CALL NO. 301
CONTRACT ID NO. 191208
ADDENDUM # 1

Subject: GRAVES COUNTY, FD04 SPP 042 0080 NEW LOC
Letting March 22, 2019

- (1) Revised - Proposal Bid Items - Pages 114-118 of 118
- (2) Revised - Plan Sheets - T1, T8, and T9

COUNTY OF	ITEM NO.	SHEET NO.
GRAVES	1-181.5	T1

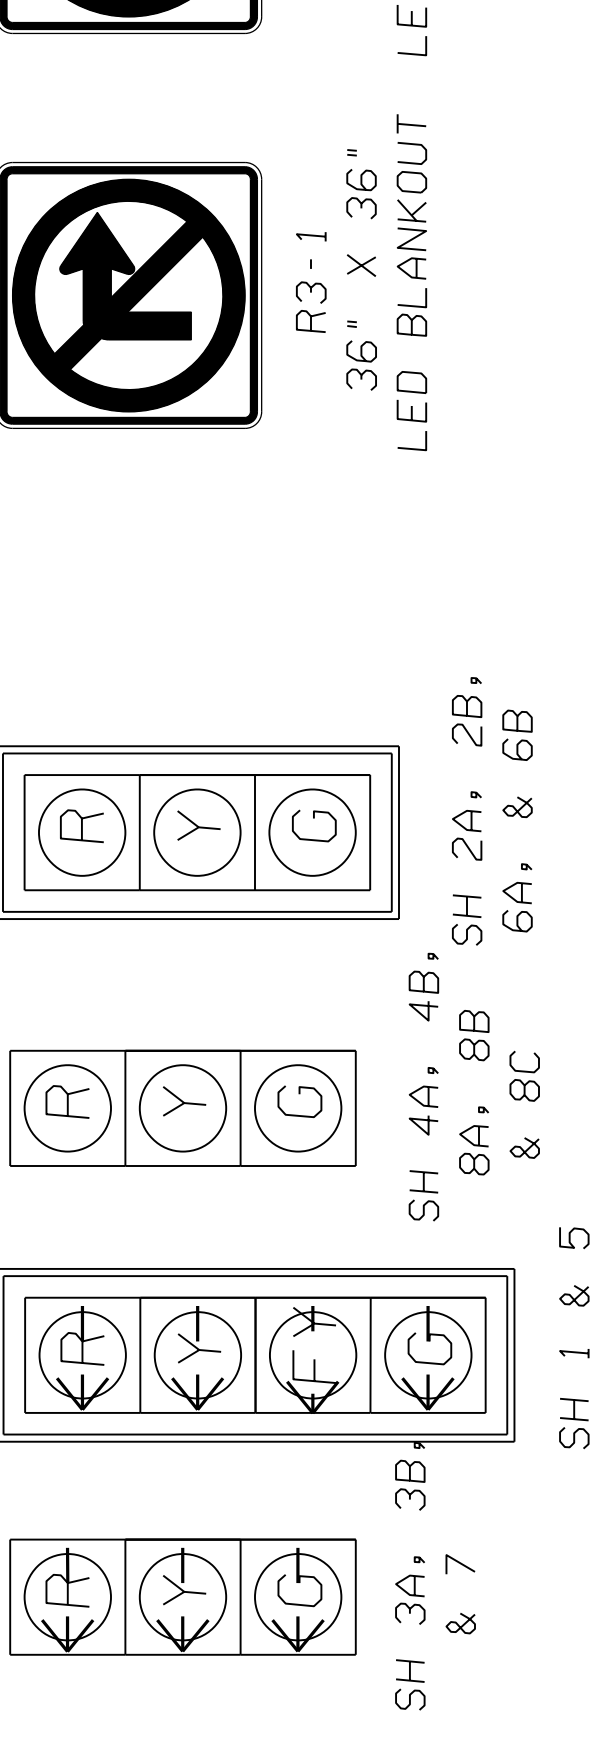
REVISED 3/15/19

COUNTY OF	ITEM NO.	SHEET NO.
GRAVES	1-181.50	T8

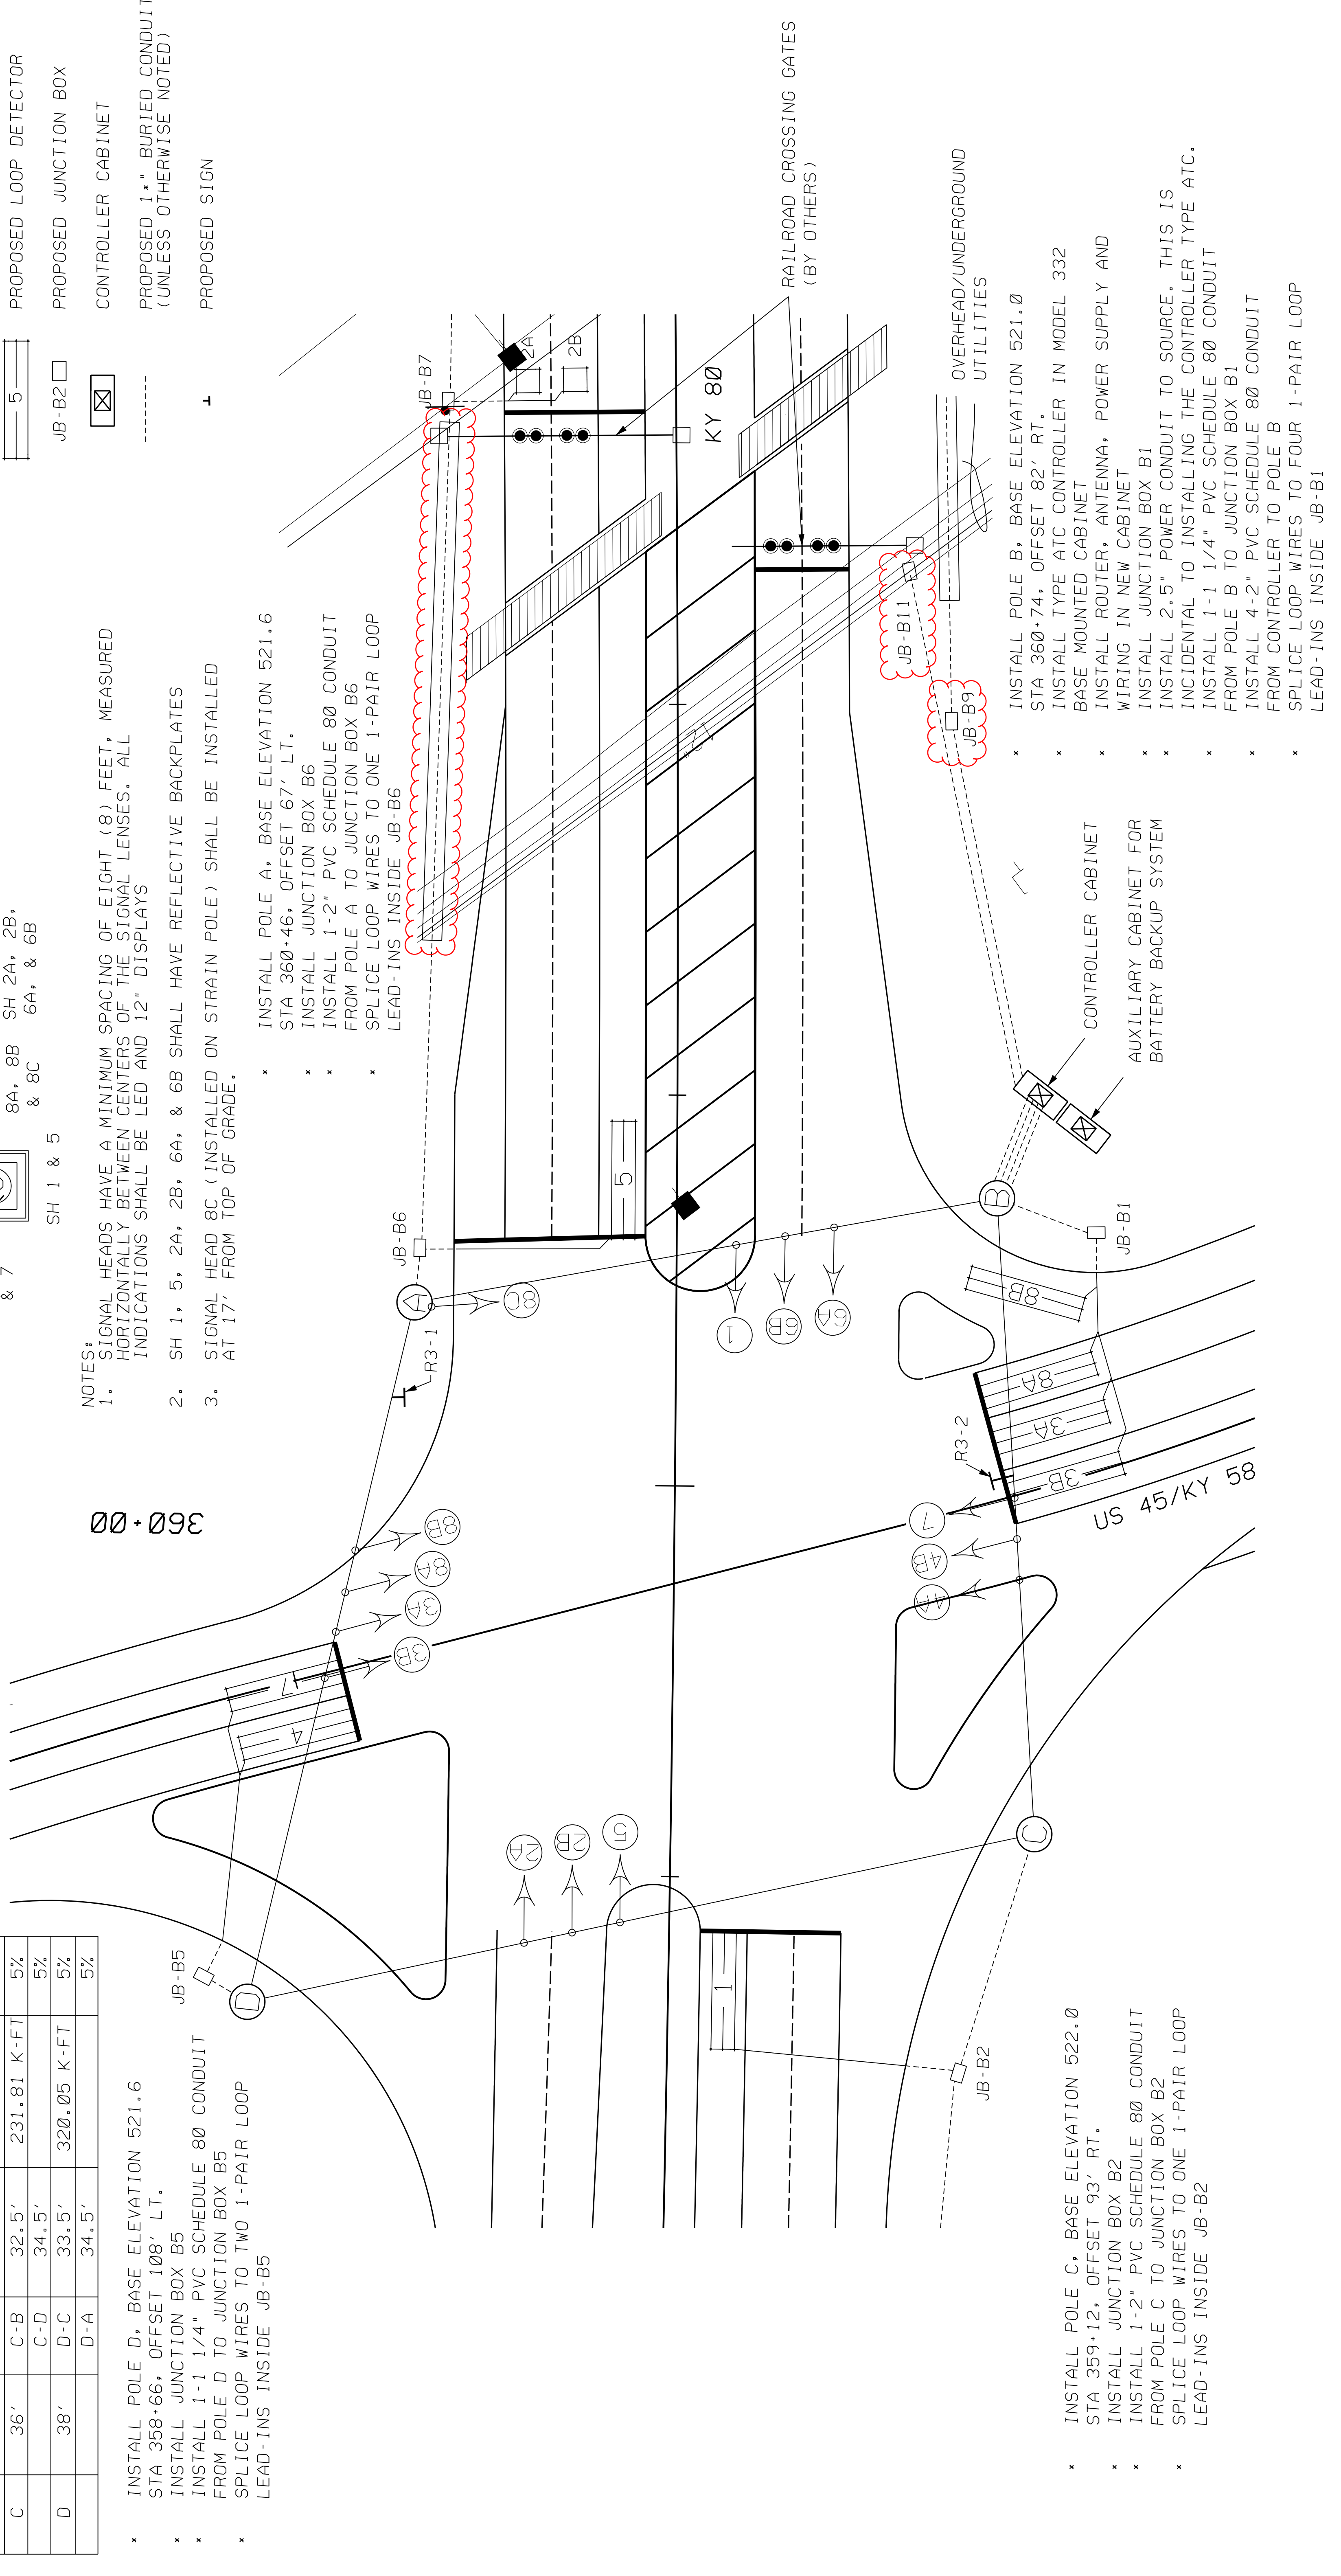
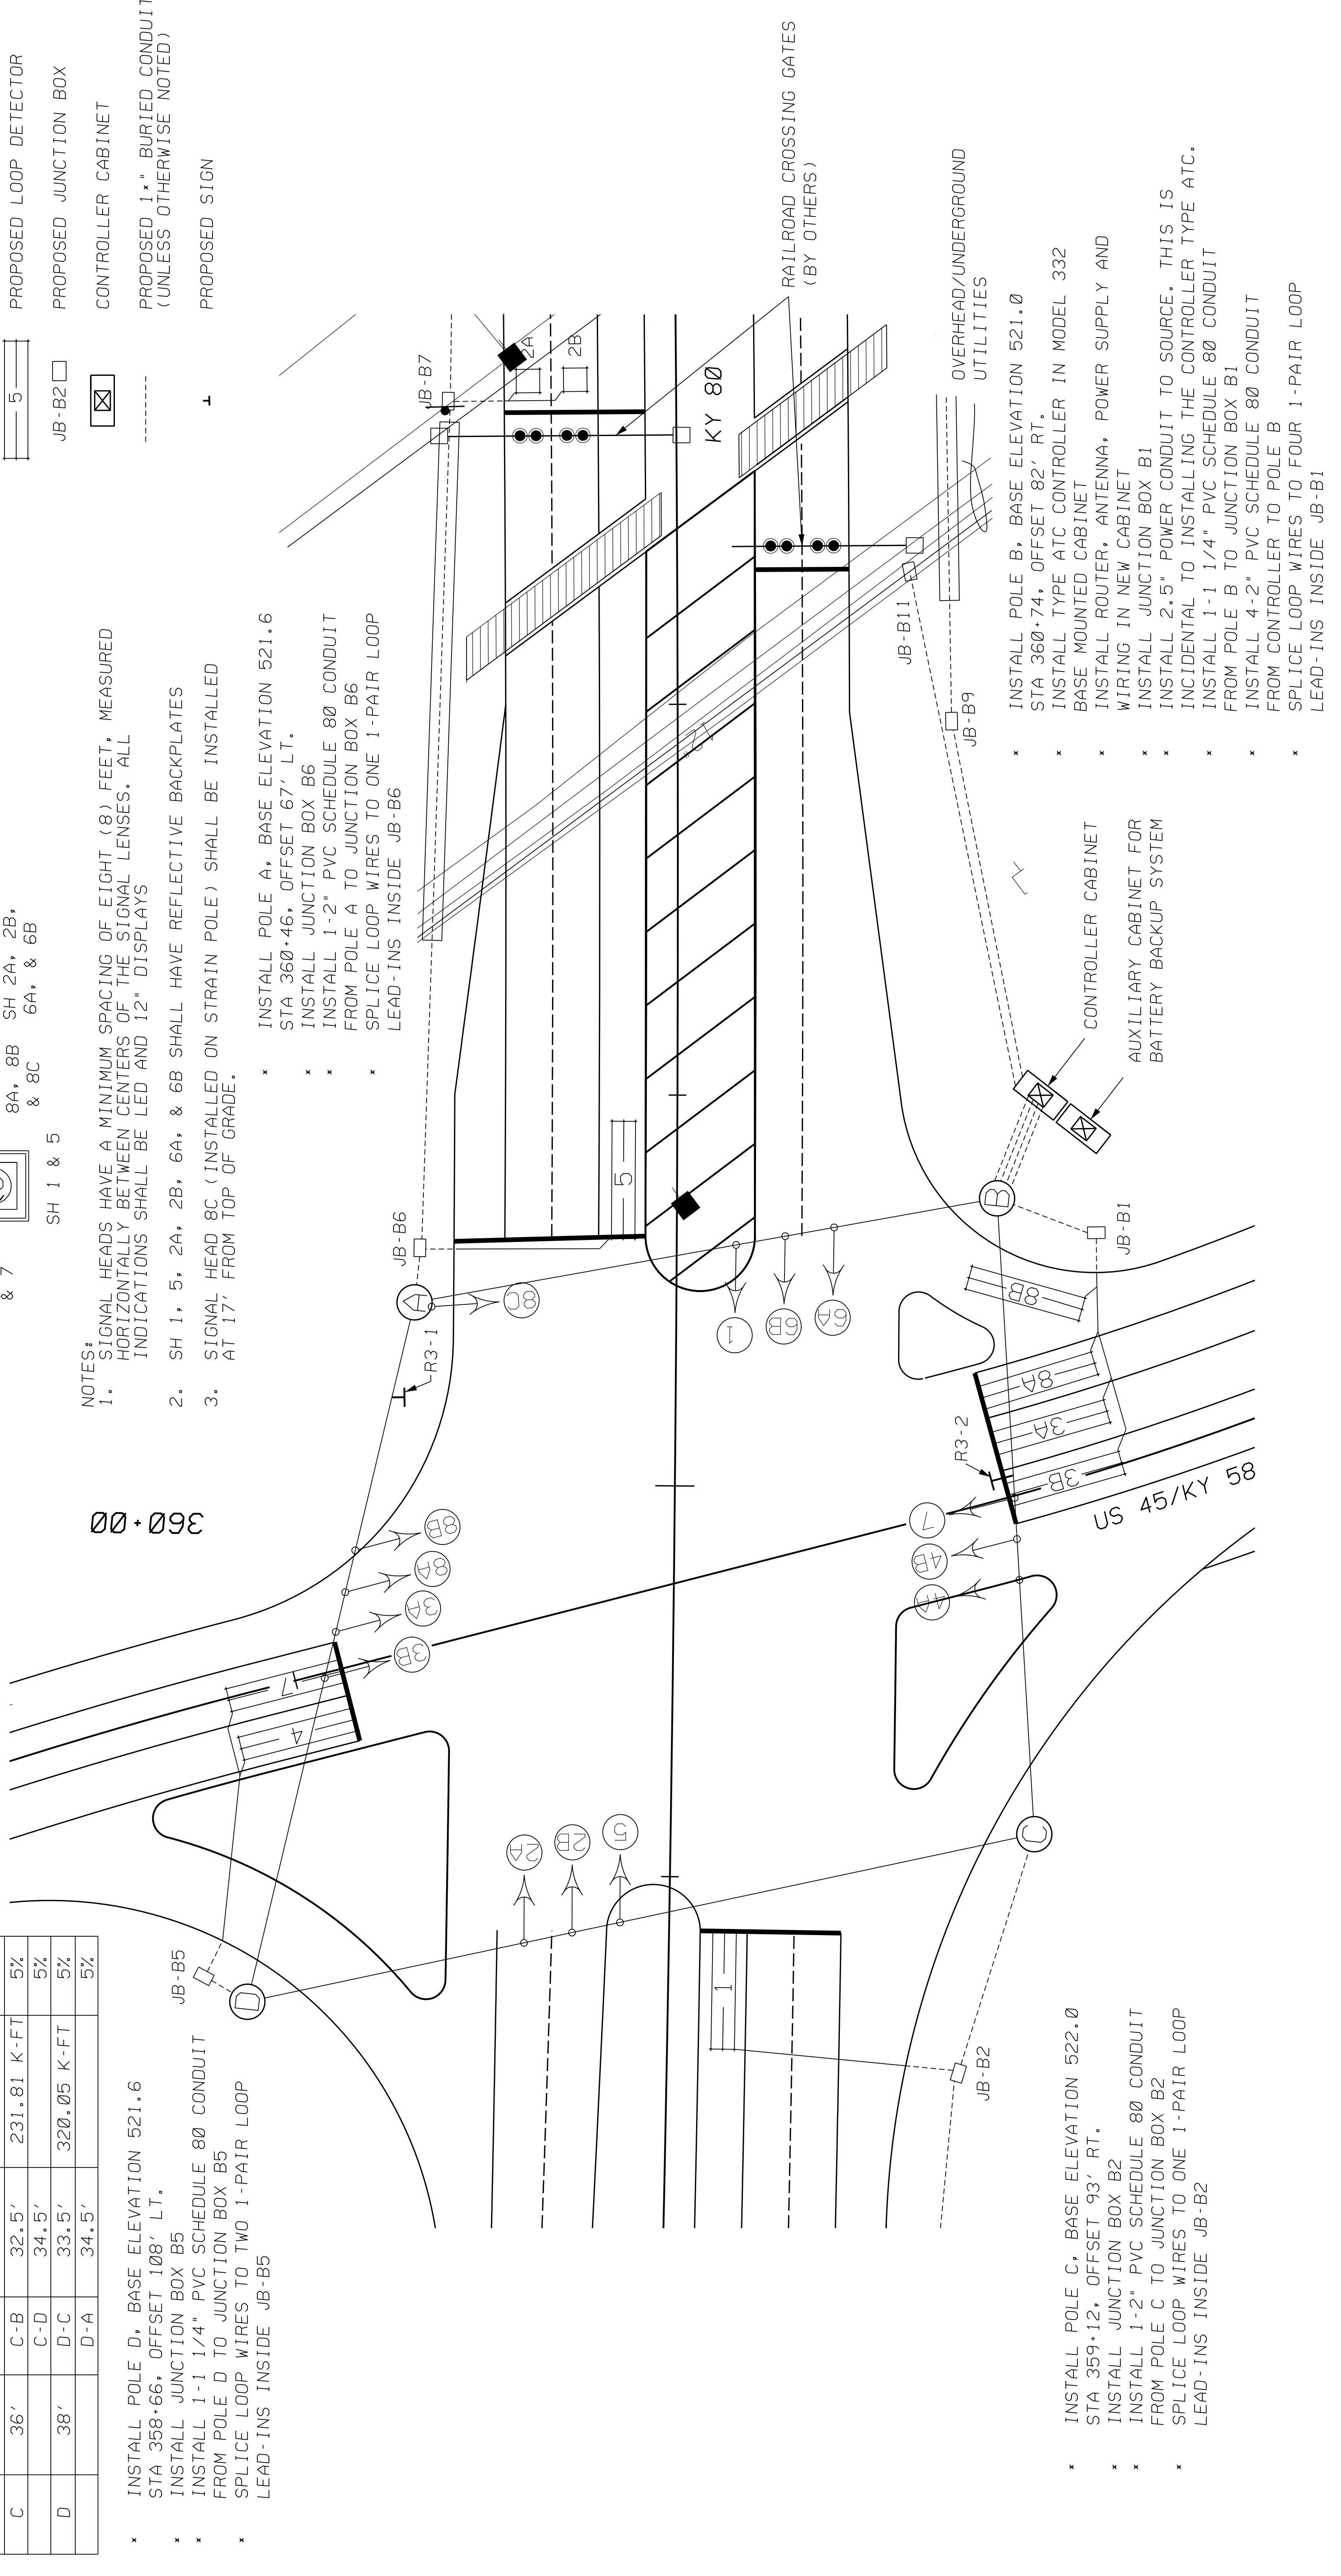
REVISIED 3/15/19

US45 / KY58 AND KY80
TRAFFIC SIGNAL PLAN
SCALE 1" = 40'

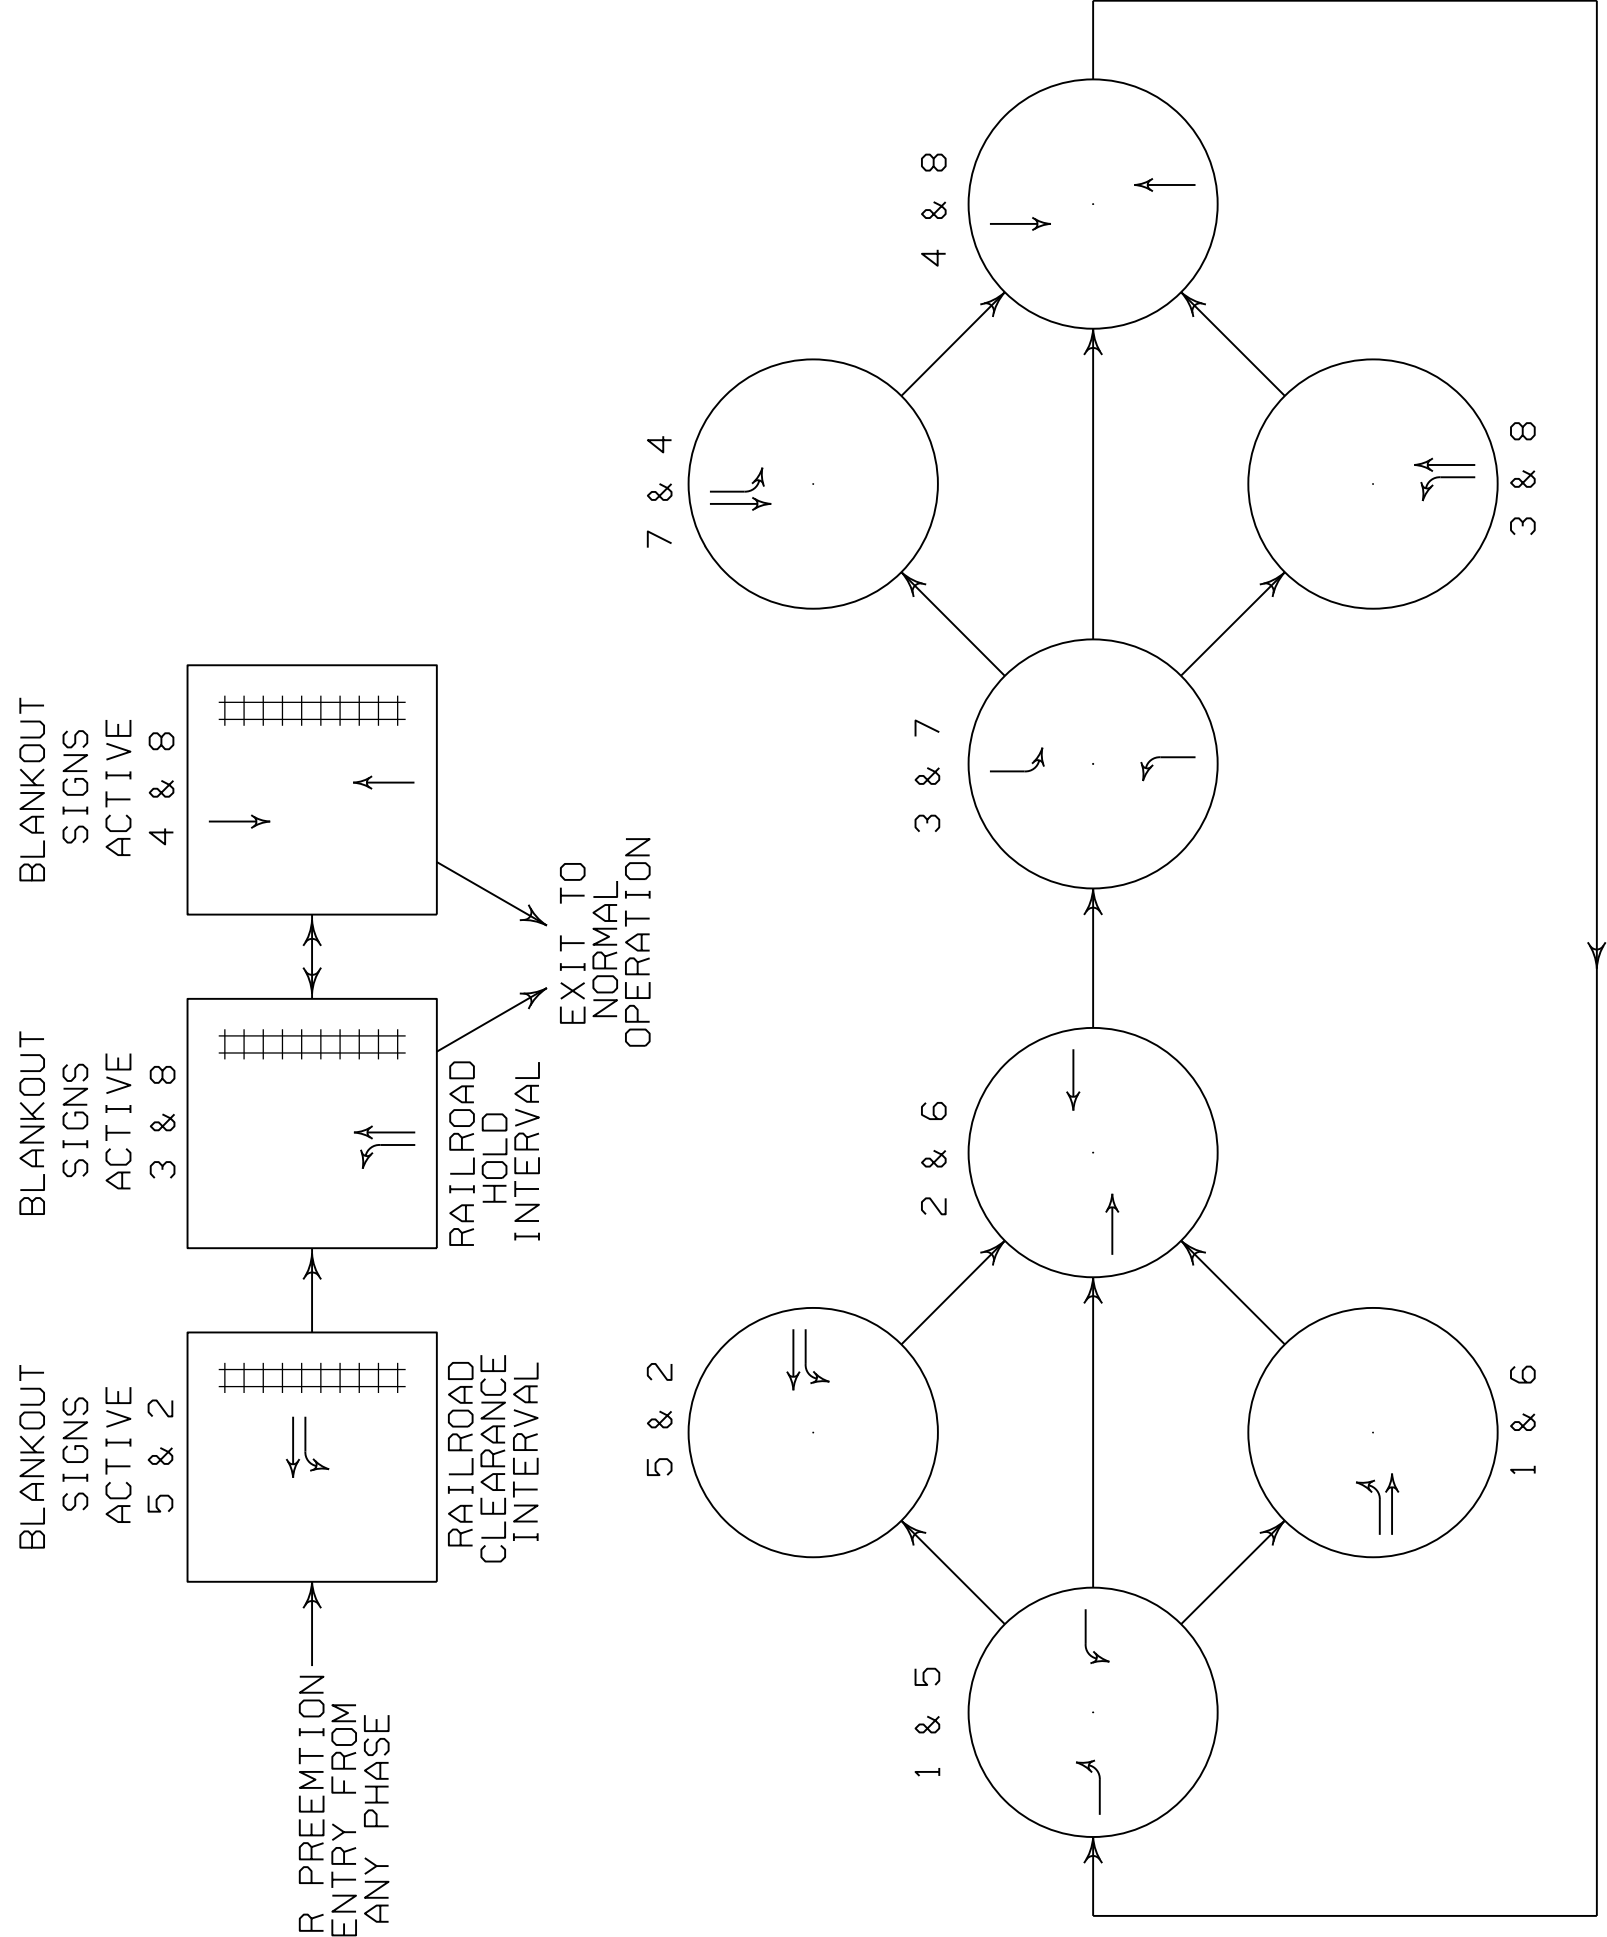
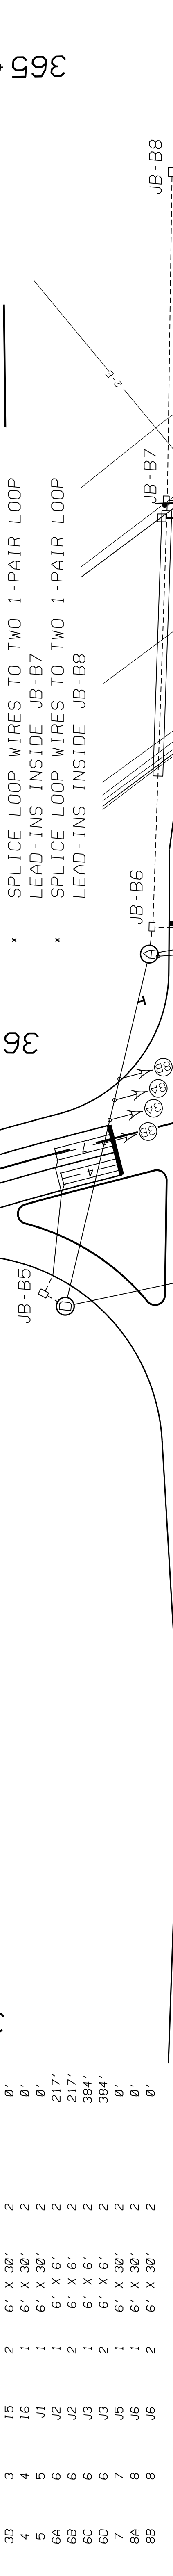
REVISIED 3/15/19
